Access Compliance Report

Public Rights-of-Way

(Curb Ramps)

Intersection ID: 22899	Main Street: LAUREL_TRACE_DR	Cross Street: OAKBRIAR_LN	Location: SE
ADA ID: 22343874EC7A	Ramp Type: Perp	Initial Pass/Fail: Fail	Overall Compliance: No
Severity Score: 12.5			
Codes/Mitigation Info/Possible Solution		Field Measurements/Component Compliance

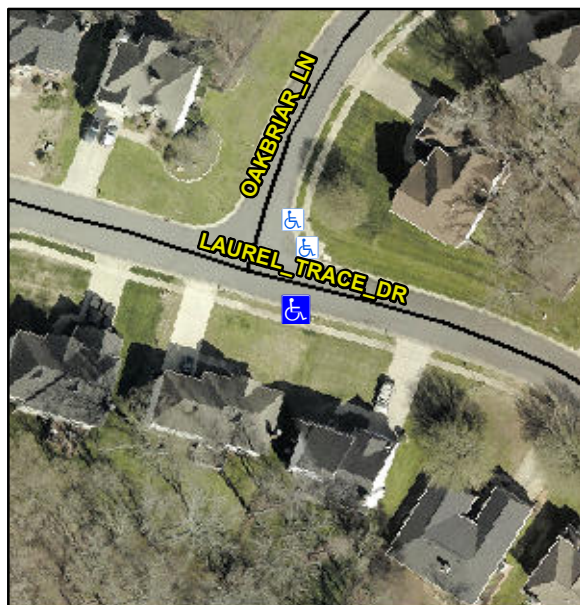
Not Found, R304.2.2

Compliance	Description	Data	Compliance	Description	Data
N/A	Ramp Length (in)	47.5	No	Ramp Slope (%)	9.0
Yes	Ramp Width (in)	48.0	Yes	Ramp XSlope (%)	1.1
N/A	Flare Type LT	N/A	N/A	Flare Type RT	N/A
N/A	Flare Slope LT (%)	N/A	N/A	Flare Slope RT (%)	N/A
N/A	Flare Traversable LT?	N/A	N/A	Flare Traversable RT?	N/A
N/A	Landing Length (in)	N/A	N/A	DWS Provided?	N/A
N/A	Landing Width (in)	N/A	N/A	DWS Contrast?	N/A
N/A	Landing Slope (%)	N/A	N/A	DWS Length (in)	N/A
N/A	Landing X Slope (%)	N/A	N/A	DWS Full Width?	N/A
N/A	Landing Curb? (Y/N)	N/A	N/A	DWS Offset (in)	N/A
N/A	Shared Landing?	N/A			
N/A	Gutter Ponding?	N/A	N/A	Gutter Slope (%)	N/A
N/A	Gutter Lip Ht (in)	N/A	N/A	Gutter X Slope (%)	N/A
N/A	Painted X Walk1?	No	N/A	Painted X Walk2?	N/A
	X Walk 1 Direction	To NE		X Walk 2 Direction	N/A
N/A	X Walk 1 Width (in)	N/A	N/A	X Walk 2 Width (in)	N/A
	X Walk 1 Slope (%)	2.3		X Walk 2 Slope (%)	N/A
	X Walk 1 X Slope (%)	0.9		X Walk 2 X Slope (%)	N/A

Remove & Replace Entire Ramp.
